VIRGINIA ELECTRIC AND POWER COMPANY
NORTH ANNA POWER STATION UNIT 2
REQUEST FOR ADDITIONAL INFORMATION
ASME SECTION XI INSERVICE INSPECTION PROGRAM
RELIEF REQUEST IWE9 CONTAINMENT TESTING

Request for Additional Information
Alternative Test Requirements
for Containment Repairs

Virginia Electric and Power Company
(Dominion)
North Anna Power Station Unit 2

Request for Additional Information
Relief Request IWE-9

DETAIL FOR LINER PLATE WELDING
NTS

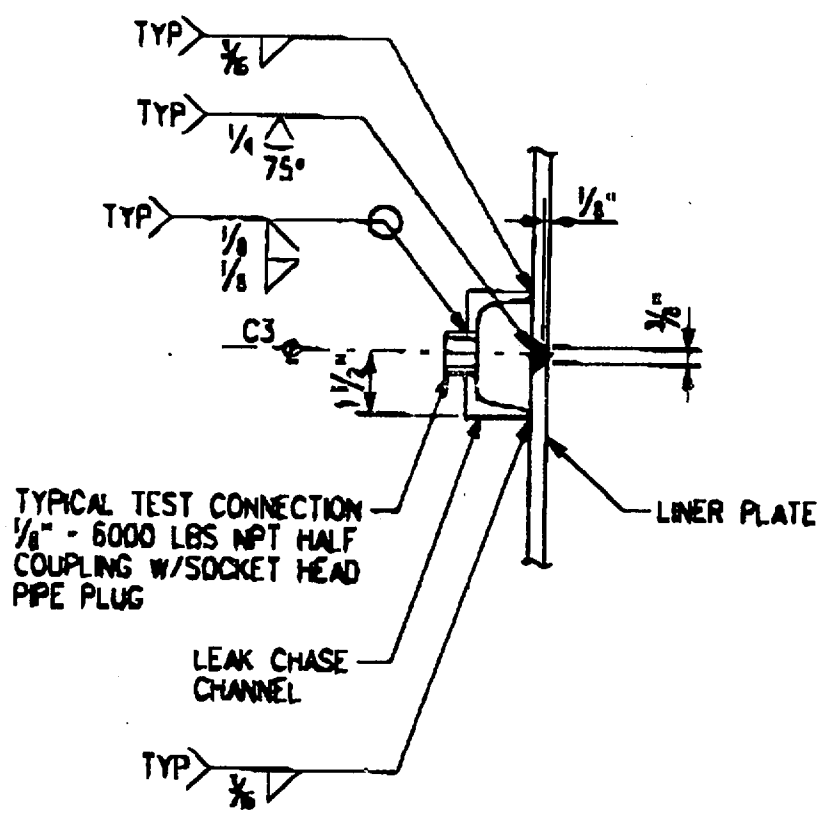
Attachment welds are planned on the metallic liner to create channels for local leak rate testing and for construction aids during liner repair and concrete placement. Please provide more detail and drawings of the channels for the leak testing.

Attachment welds on the metallic liner are required to attach the leak chase channels to the liner. These leak chase channels will be used to perform a local leak rate test of the liner's repair weld. The local leak rate test will confirm the leak-tight integrity of the repair weld and the channel attachment welds.

The enclosed drawings illustrate typical channels and construction aids.

LINER PLATE RESTORATION PROCEDURE/SEQUENCE

1. Weld the cut section of the liner plate to insitu liner plate, at the temporary construction opening, with full penetration weld.

2. Perform Magnetic Particle Testing (MT) examination of the completed full penetration weld.

3. Perform vacuum box test on the completed full penetration weld.

4. Perform Radiographic Testing (RT) examination of the completed full penetration weld.

5. Seal/fillet weld leak chase channels centered over the perimeter of the full penetration liner plate weld.

6. Perform MT examination of the seal/fillet weld.

7. Pressurize the leak chase channels to 50 psi, and monitor for leakage. Repair leaking welds as necessary, and retest until no leakage is observed.
